# SAFETY BULLETIN

**Bulletin Part Number:** 267218-SB1

**Product:** Acoustimass® AM-6 series III, AM-10 series III, AM-15 series I,II and AM-16 Bass Modules.

**Subject:** Replace capacitor p/n 133623-473 in locations C872 and C873 on the Amplifier PCB.

Figure 1: Amplifier PCB

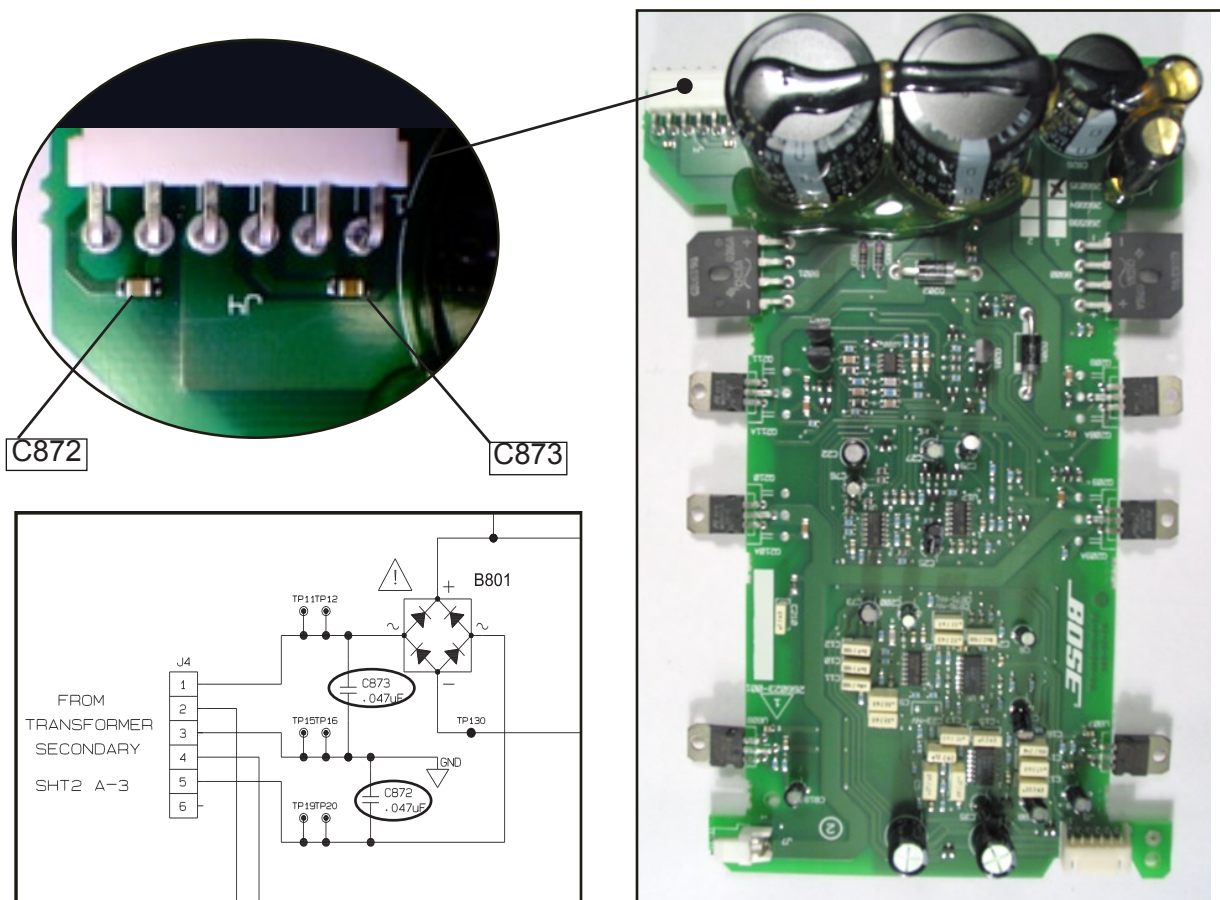
**Solution:** Using the respective disassembly/assembly procedures in the AM-6 series III (267218), AM-10 series III (267217), \*AM-15 series I (198696), AM-15 series II (267216) and AM-16 (267216) service manuals remove the Amplifier PCB. Replace capacitors C872 and C873 with the new "Fail Open" capacitor, p/n 286499-473, refer to Figure 1 for the locations of the capacitor.

Using a permanent black marker, mark the top-center of connector, J4, with a ~1/4in diameter black dot. This will indicate that the capacitors were changed.

**Disposition:** Replace C872 and C873 with capacitor p/n 286499-473. This modification is to be performed on all Acoustimass systems mentioned above prior to DOM = 5031.

Figure 2: AM-15 Series I Amplifier PCB

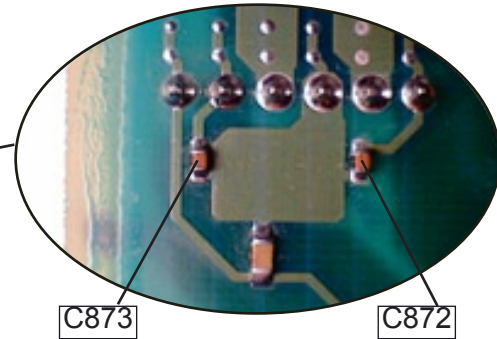
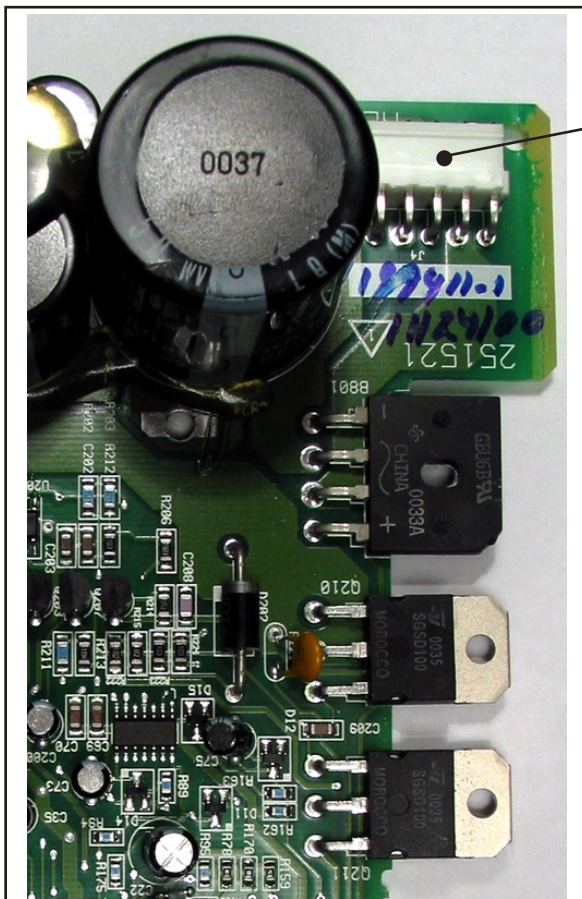
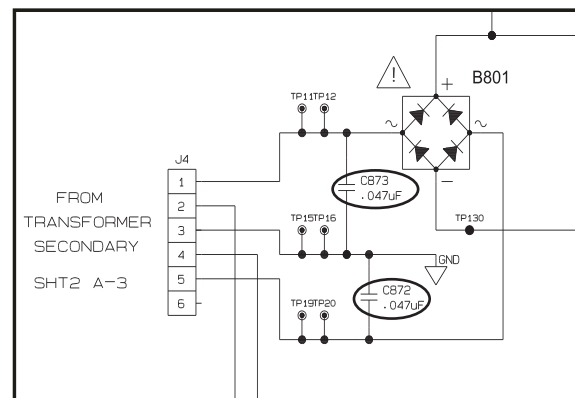
\*Note: Refer to Figure 2 for locating capacitors when repairing the AM-15 Series I.
